Public Notice

B. Name of Subdivision: Wyndmoor Court

July 27, 2021
Mark Penecale, Planning Director
Springfield Township
Reference: Wyndmoor Court – Two Lot Subdivision Application

Re: MCPC # 21-0199-001
Plan Name: Wyndmoor Court
(1 lot comprising 2.042 acres)
Situate: 7602 Pine Rd: East Ln (N) Ivy Hill Road (S)

SITE LANDSCAPING PLAN FOR WYNDMOOR COURT FINAL SUBDIVISION PLAN

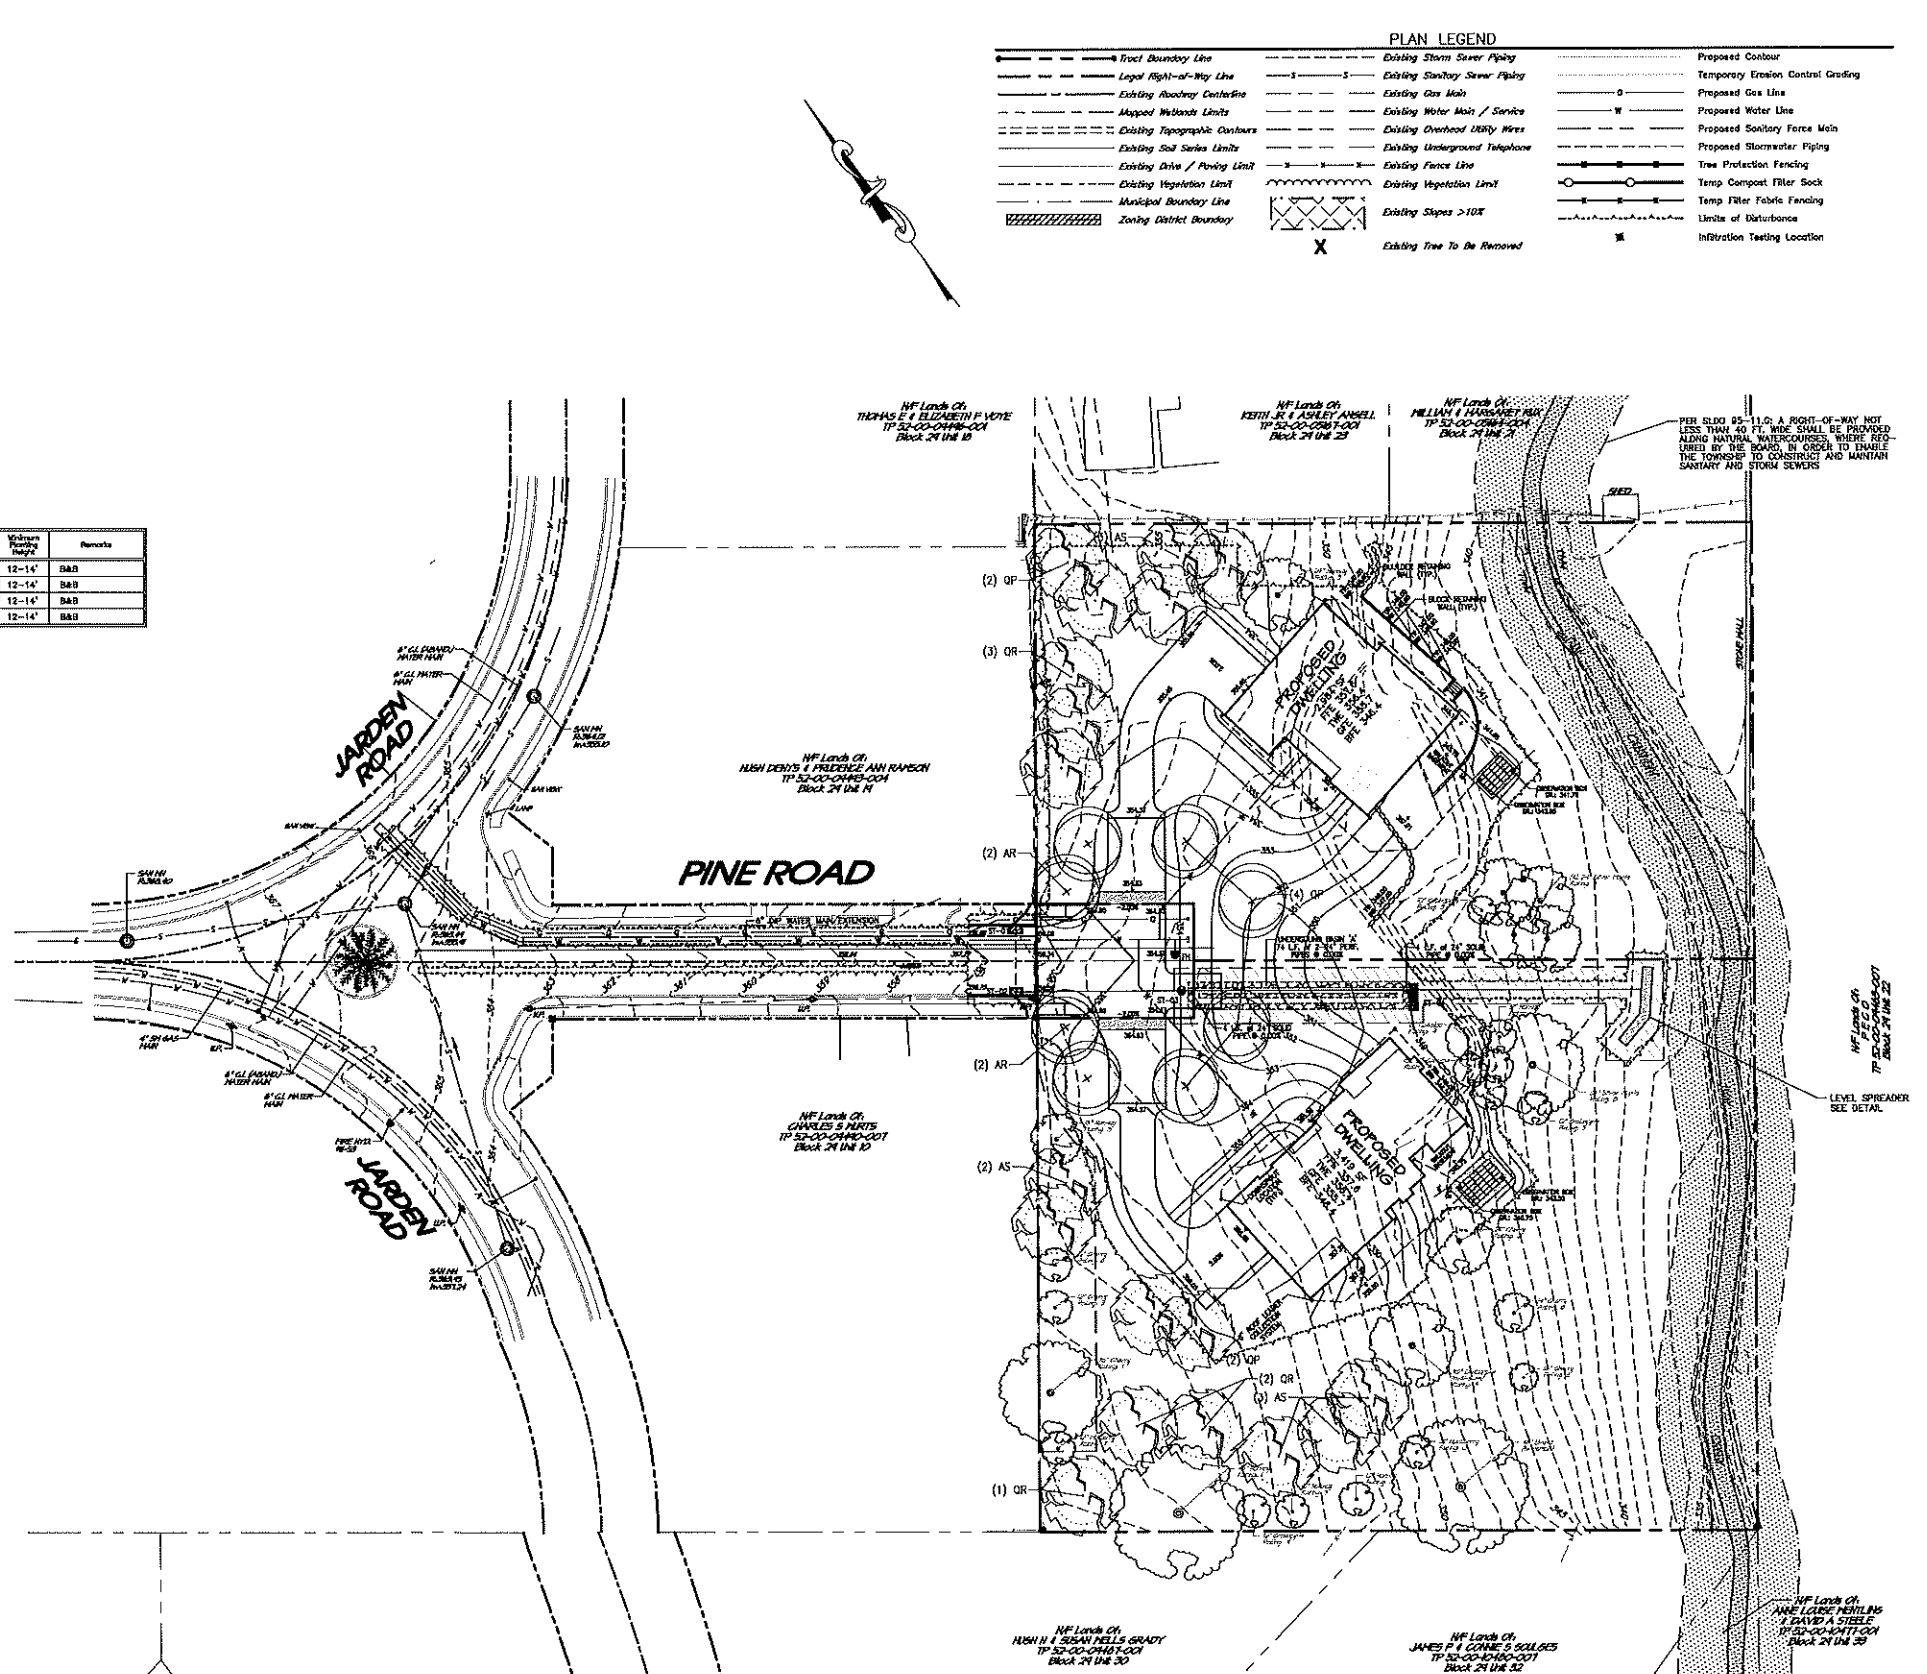
7. Chapter 95-11.I.(11)(c) – Specifies that any tree over three inches in caliper which must be removed shall be replaced at a rate of two new trees to each one tree removed with approved trees of two to 2 1/2 inches caliper. The Landscape Requirements table on the Landscape Plan notes that trees with a rating of at least 7 out of 10 were considered in the replacement tree calculations. The Landscape Requirements table must be revised to specify trees with a rating of 5 or 6 shall be replaced at a rate of 1 new tree for each tree removed and the replacement tree calculations must be revised as necessary.

It is not clear that this planting obligation has been addressed..

- A. Tree Rating Assessment. The tree assessment provided by the applicant on page 5 of the plan set is dated May 17, 2016, which is now over five years old. This may need to be updated in order to obtain a recent assessment of the health of trees currently on site, as this might affect the number of replacement trees required per section 95.11.1.(12)

- B. Number of Replacement Plantings. The applicant is proposing a one-to-one replacement for trees rated 5-6 (on a scale of 1-10) as opposed to the two-to-one tree replacement required in section 95.11.1.(12). The applicant should conform to this requirement or request a waiver from the Township.

7. The Landscaping Requirements are listed on Sheet 5 which include eight (8) Street Trees and eighteen (18) replacement trees based modified tree replacement standards that the Township previously specified. The plan proposes twenty-six (26) new trees to be planted and proposed to remove twenty-three (23).

TYPICAL STONE LEVEL SPREADER DETAIL

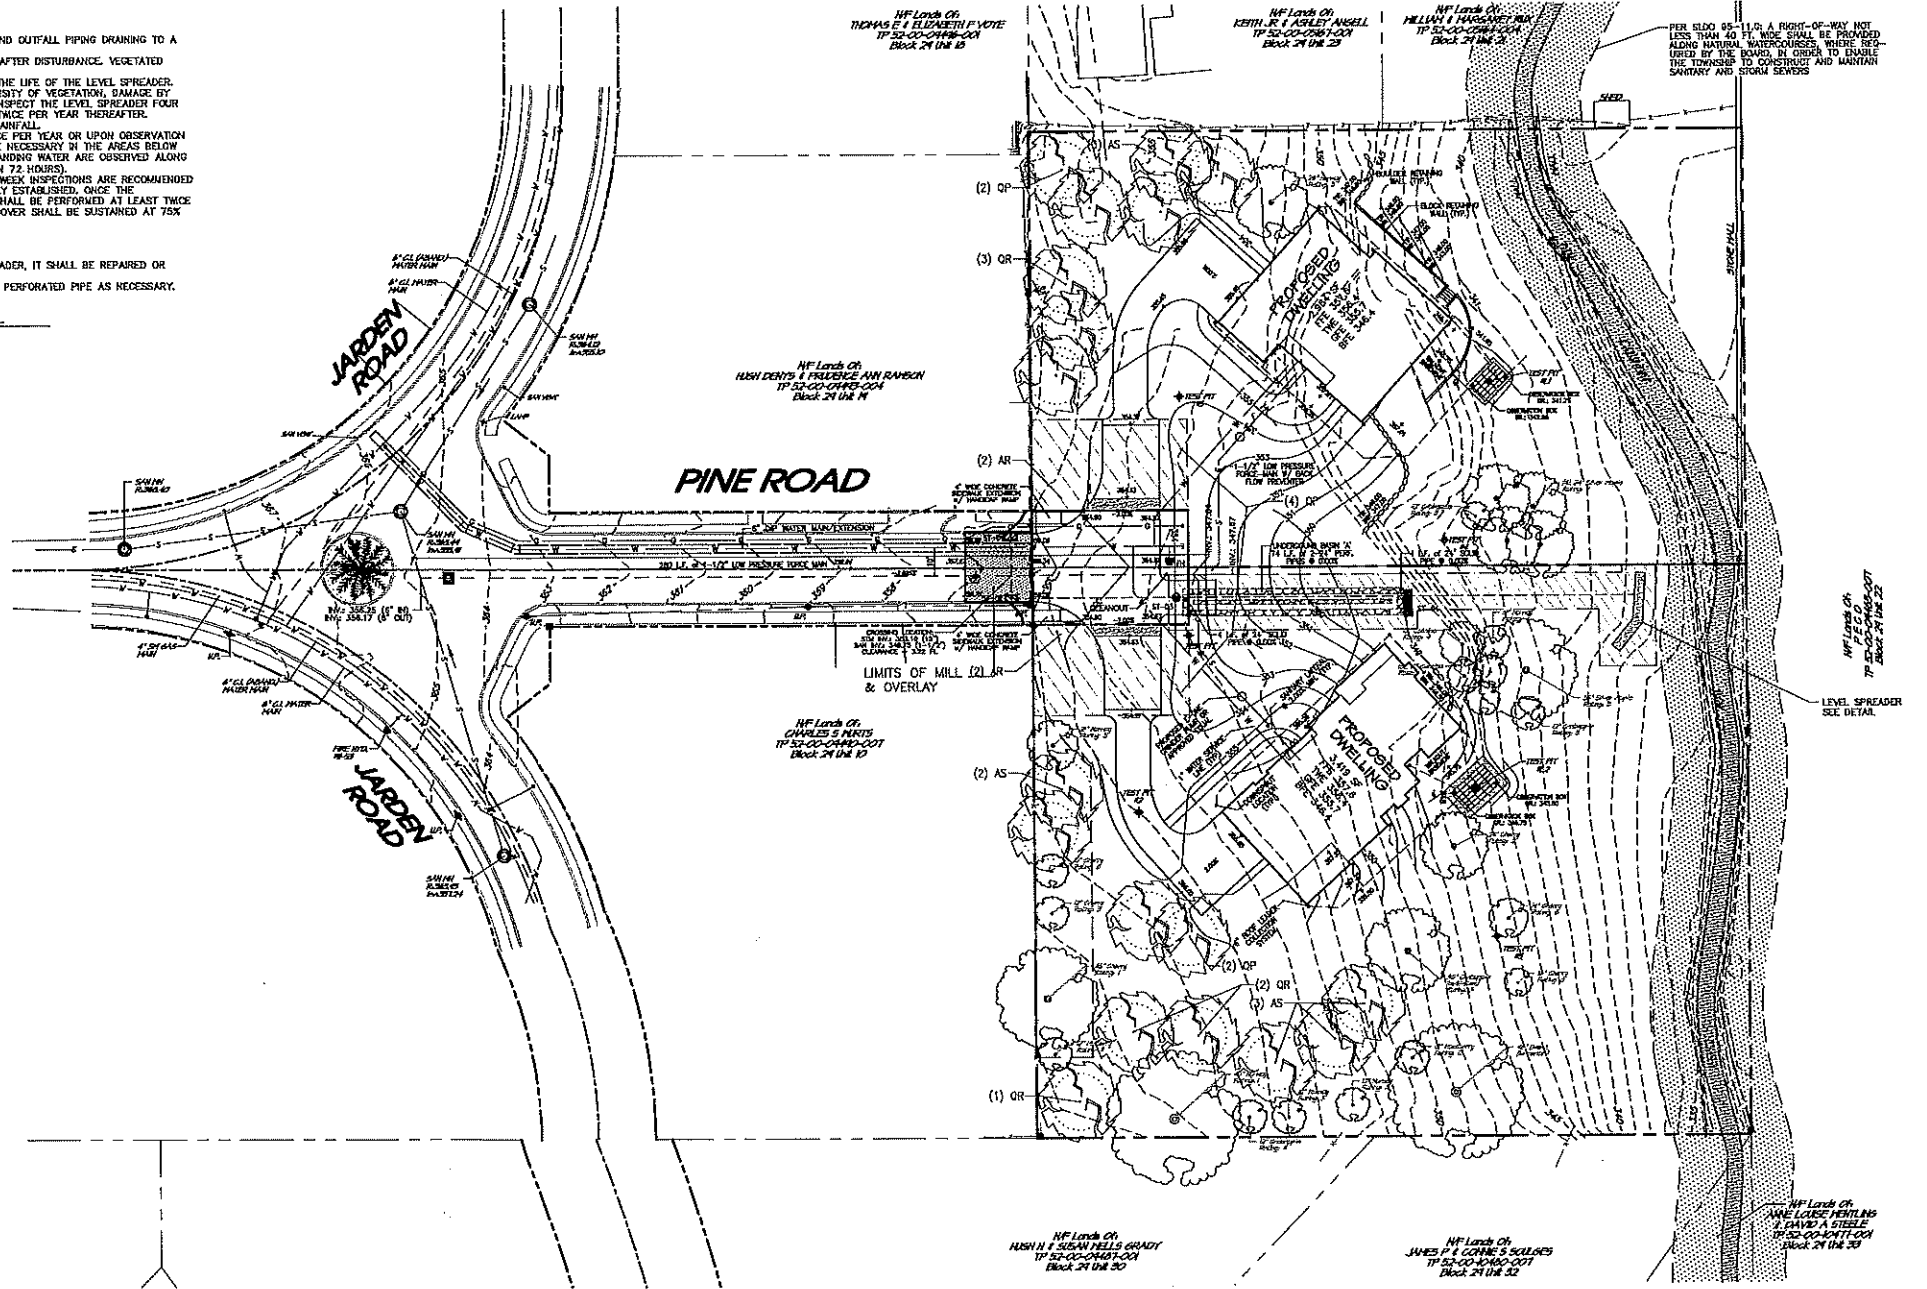
14. On the 'Post Construction Stormwater Management Plan', Sheet 8, please indicate the invert in, pipe length, and pipe slope of the inflow pipe into the Level Spreader.

13. The pipe schedule on sheet 4 is amended to distinguish between the perforated and solid piping between ST-03 and ST-04.
 14. Additional information for the inflow pipe on the level spreader detail has been added to the plans.

STORMTANK SYSTEM - LOT 01
Scale: 1" = 5'

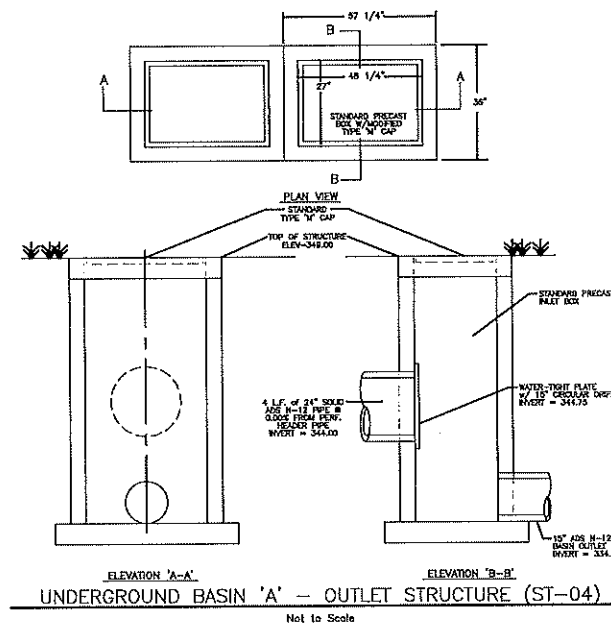
7. Please revise the labeling of inflow and outflow points on the 'StormTank System – Lot 01' detail on Sheet 10.

UNDERGROUND BASIN 'A' - OUTLET STRUCTURE (ST-04)
Not To Scale

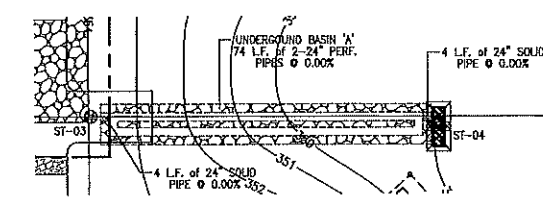
10. On the 'Site Improvements Plan', Sheet 4, the Structure Schedule information for Inlet ST-04 does not match the detail on Sheet 10 or the Basin Routing information in the PCSM Report.

12. On the 'Site Improvements Plan', Sheet 4, the Stormwater Profile information for Inlet ST-04 does not match the information in the Stormwater Structure Schedule, the detail on Sheet 10.

- Additional perimeter controls have been added downslope of the level spreader.
10. The inlet data and notes on sheet 4 for ST-04 has been made consistent with the detail and the stormwater routing.

11. The structure and pipe schedule have been corrected to accommodate the level spreader revision.
 12. The inlet data and notes on sheet 4 for ST-04 has been made consistent with the detail and the stormwater routing.
